Outside Door Weatherstrip - Multiple Concerns

YEAR(S)	MODEL(S)	ADDITIONAL INFORMATION
2013 – 2014	FR-S

REVISION NOTICE

June 16, 2014 Rev1:

Figure 2.

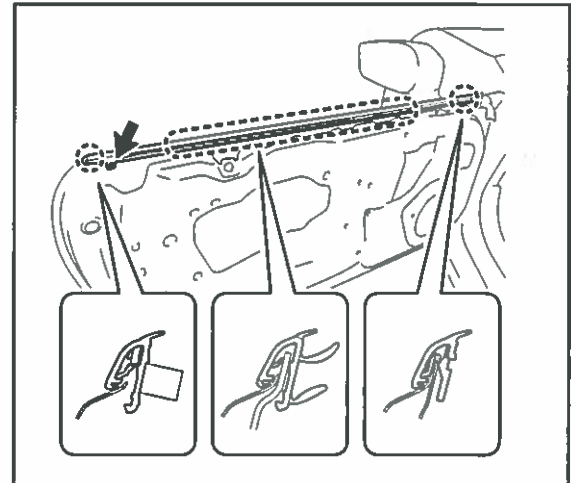
2. Install front door glass Outer Weatherstrip assembly.

Engage the claws to install the screw and a NEW front door glass Outer Weatherstrip assembly as shown.

Ensure proper installation of Outer Weatherstrip by confirming that the claw attached to the weatherstrip is fully engaged.
